| Project Title: | Carlsbad Energy Center - Compliance |
| Document Title: | Project Owner's Responses to Data Requests in Set One (Nos. 1-30) |

Re: Carlsbad Energy Center Project Petition to Amend (07-AFC-06C)
Project Owner's Responses to Data Requests in Set One (Nos. 1 - 30)

Data Response Set 1 (Responses to Data Requests 1 to 30)

CECP
CONCEPTUAL ONE-LINE DIAGRAM

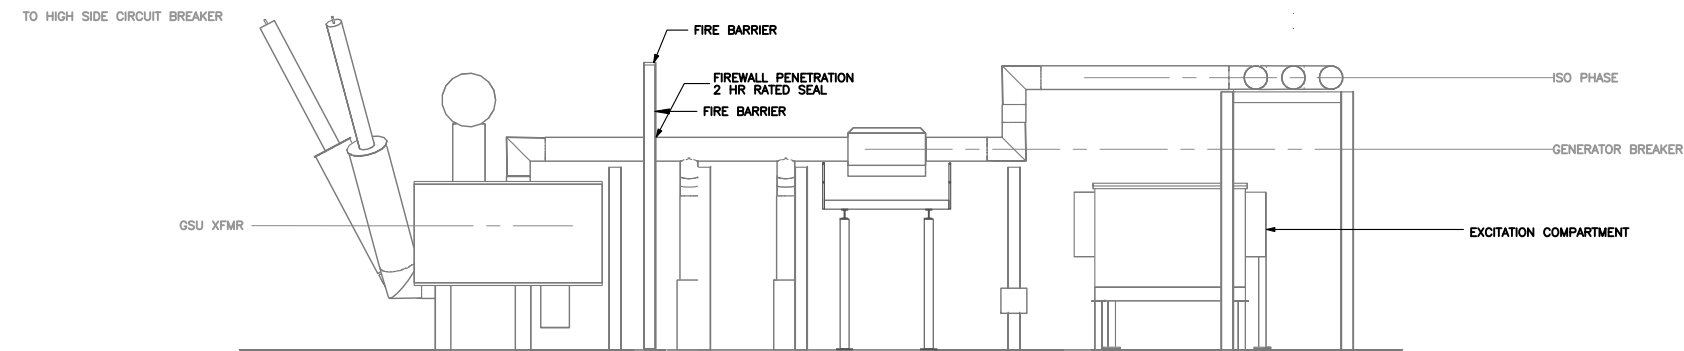
21. Provide a complete electrical one-line diagram (or resubmit Figure 2.1-2 with size/ratings of the applicable equipment and/or missing elements) of the four proposed CECP 230 /13.8 kV switchyards, one for each of the proposed CTG Units 6, 7, 8 and 9, and also for the two proposed 138/13.8 kV switchyards for CTG Units 10 & 11. The diagrams should show all equipment for the interconnection facilities within the switchyards including sizes and/or ratings as follows:

Response: An updated one line diagram is provided with the requested information, Figure DR21-1. The maximum generated output of the generator @PF 0.85 is 131.8MW. The generator will be limited by combustion turbine and the site conditions as shown in Appendix 5.1B – Detailed Emission Calculations - Table 5.1B-2 GE Performance Runs in the PTA.

230kV TAKEOFF STRUCTURE (TYP)

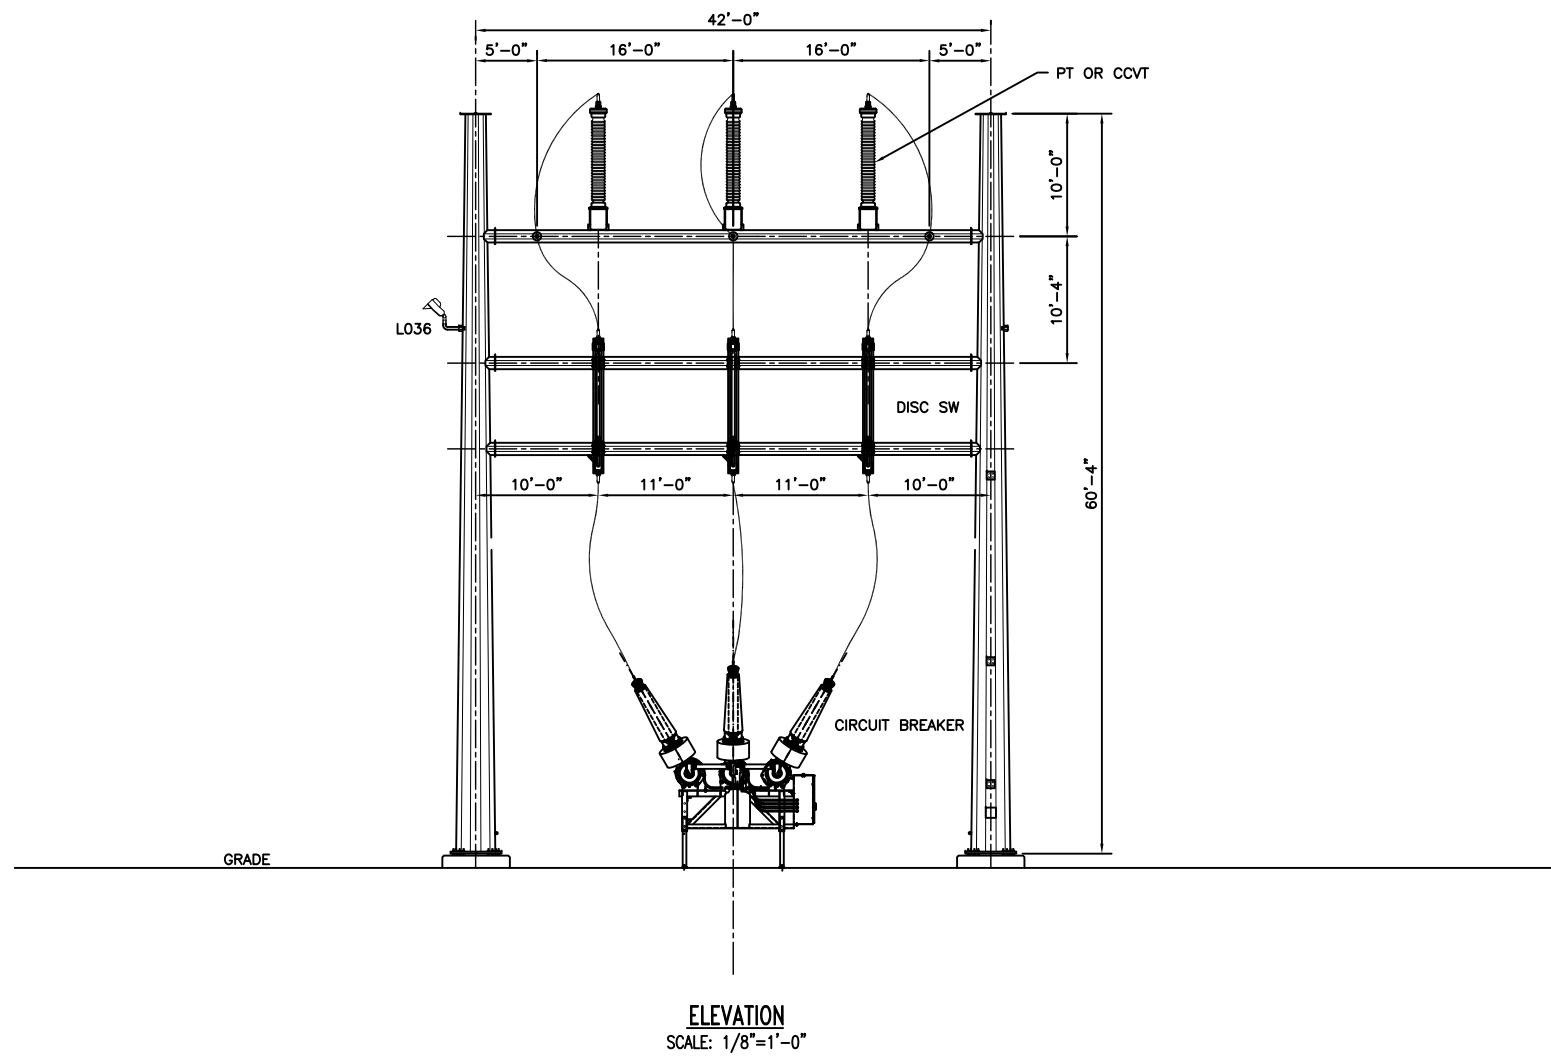
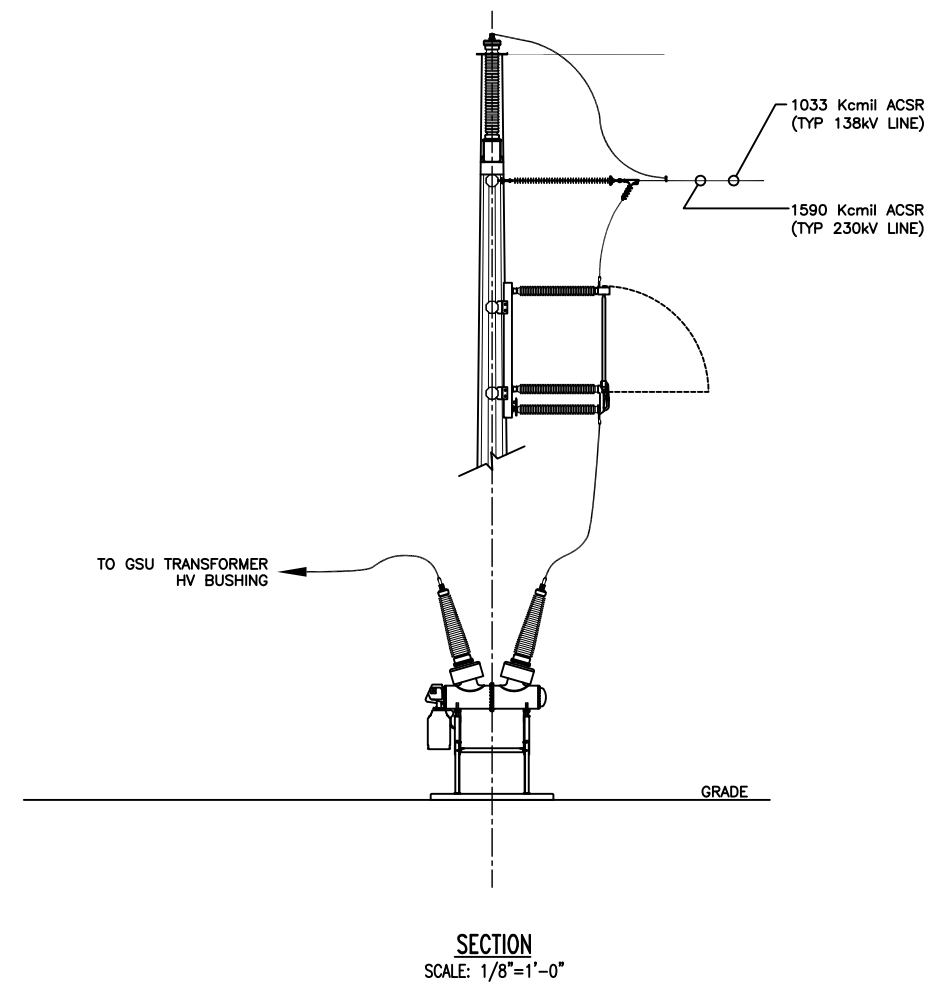
22. Provide a clear leveled physical layout drawing of the CECP 230/13.8 kV and 138/13.8 kV switchyards showing all major equipment (generators, buses, transformers, breakers, buses and disconnect switches etc.) and transmission line outlet(s).

Response: The physical layout of the generator and transformer for the 230kV switchyard are provided in Figure DR22-1. The physical layout of the breaker, switches and 230kV takeoff structures are provided in Figure DR22-2. The same equipment for the 138kV switchyard will be substantially similar to that depicted in Figures DR22-1 and DR 22-2.

DRAWING NUMBER
1009704020-D10a

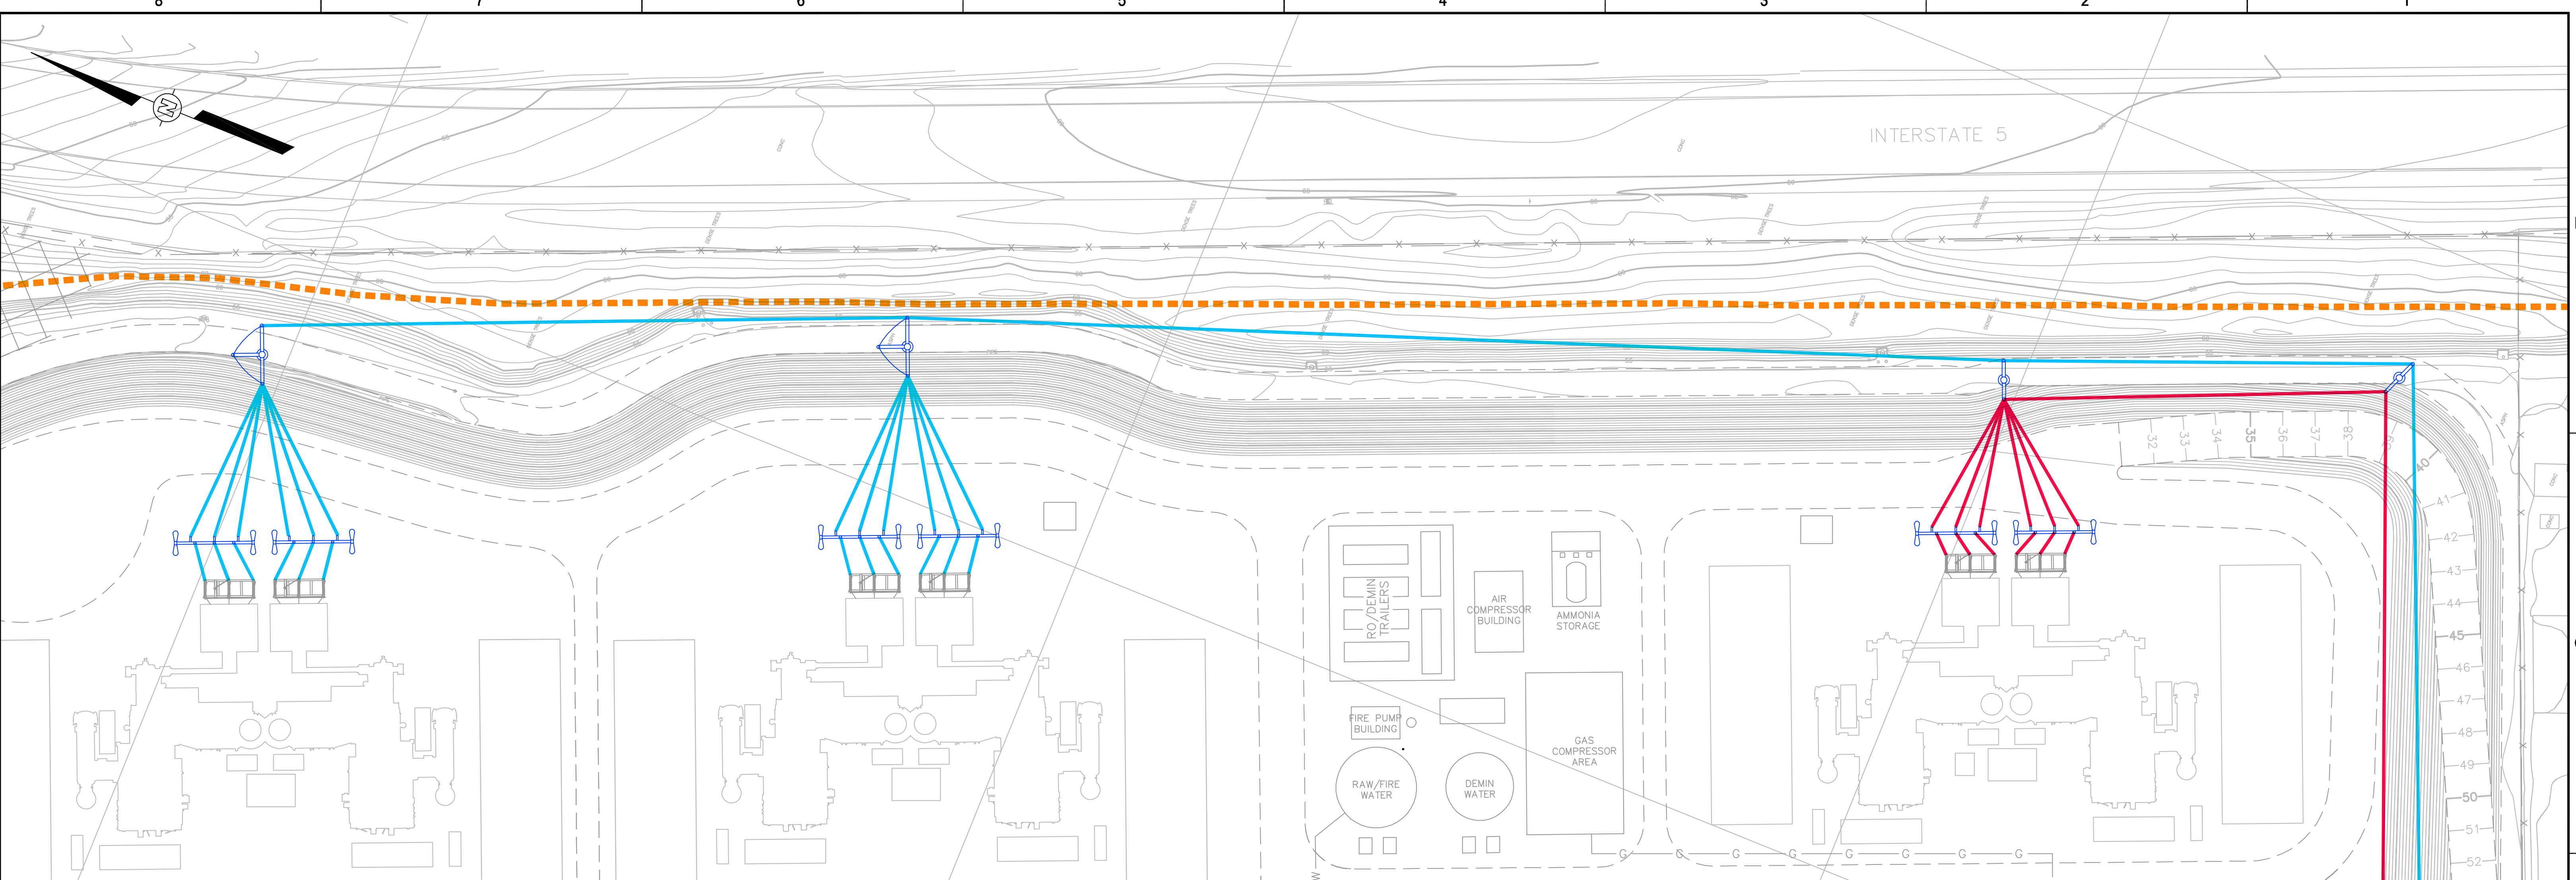
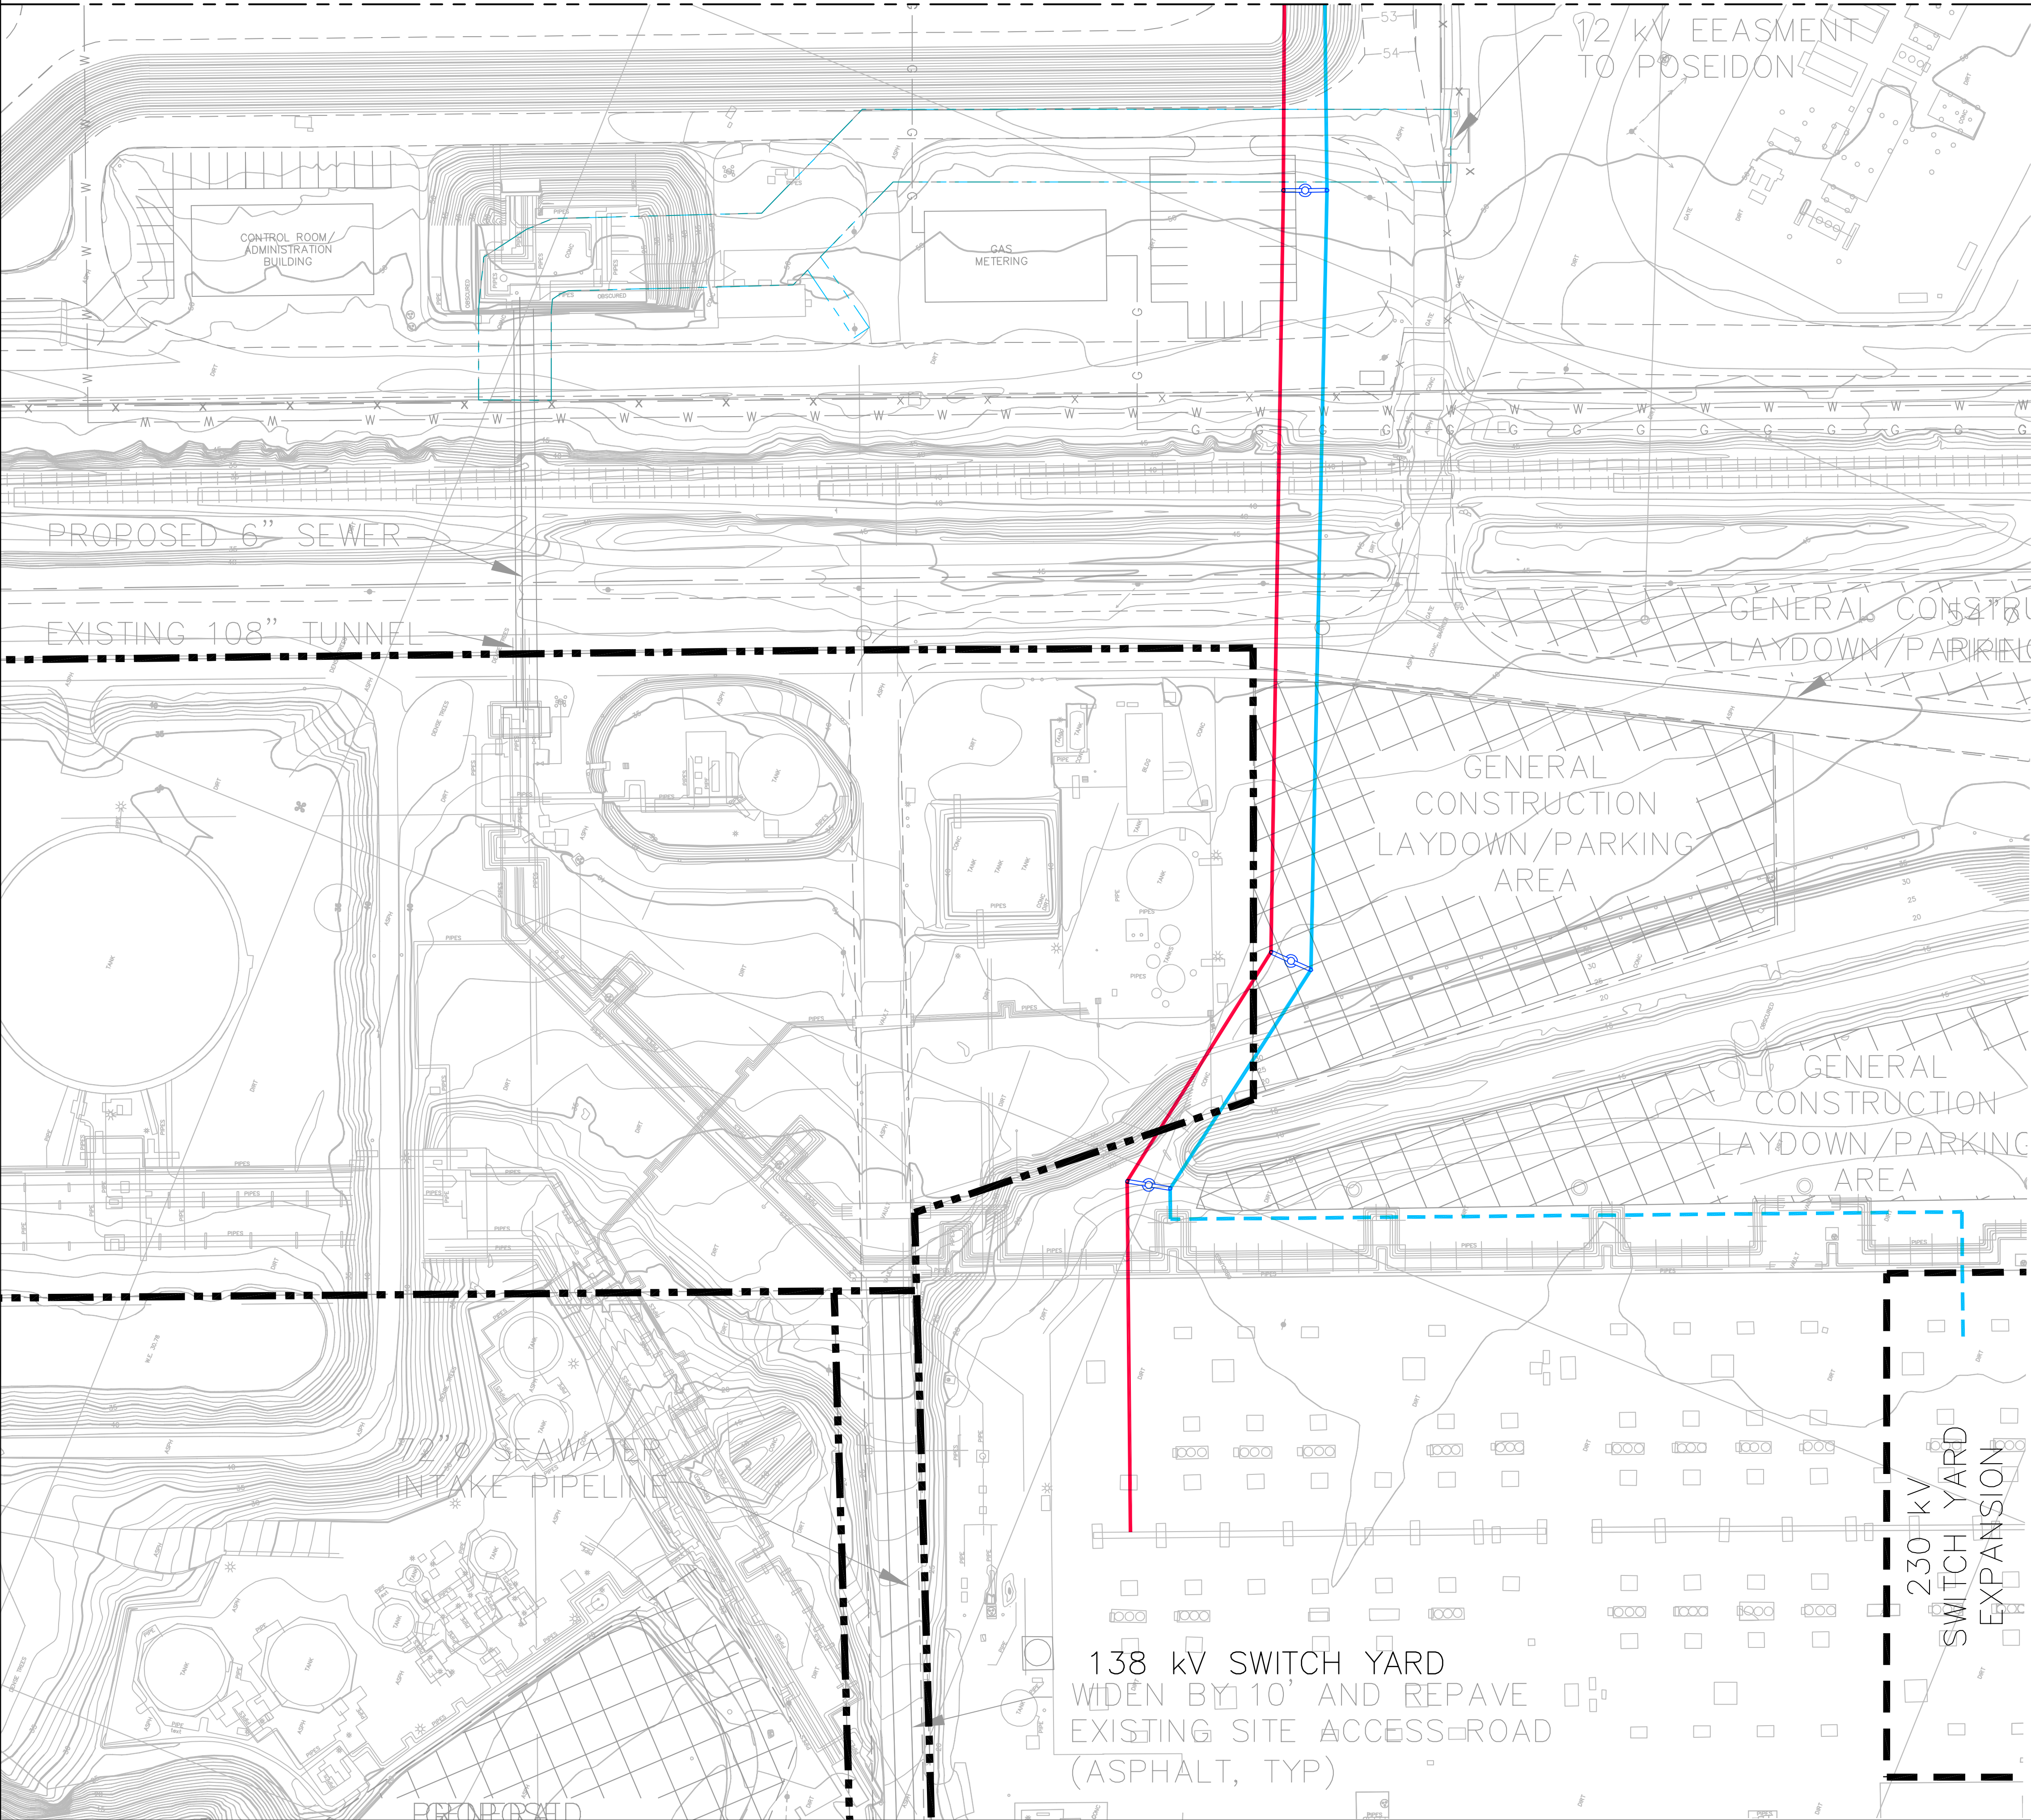
23. Please provide a discussion and drawing of the physical layout showing distinctly (in a larger scale) the preferred route(s) (along any road, land, transmission line or power station) of the following overhead and underground gen tie lines including their right of way (ROW) width(s) between the proposed Amended CECP 138/230 kV switchyards and SDG&E 138/230 kV Encina Power Station (EPS) switchyards. Describe whether the ROW would be through private and/or public lands (including land west of the railroad tracks following demolition activities sought by the Petitioner in the PTA).

Response: As requested, Project Owner provides an enlarged transmission line depiction that is split into 2 segments, which are shown on Figures DR23-1 and DR23-2. Project Owner will own the transmission lines and structures between the Amended CECP facility and SDG&E's switchyards. As depicted in the accompanying Figures, the Amended Project will not include construction of a new switchyard. Power will be transmitted to the applicable SDG&E switchyard in the manner described below. All land over which these lines will pass is and will continue to be owned by private parties. Any future right of way that Project Owner determines is necessary for these lines will be at least 125 feet wide, depending upon spatial constraints at the Project site.
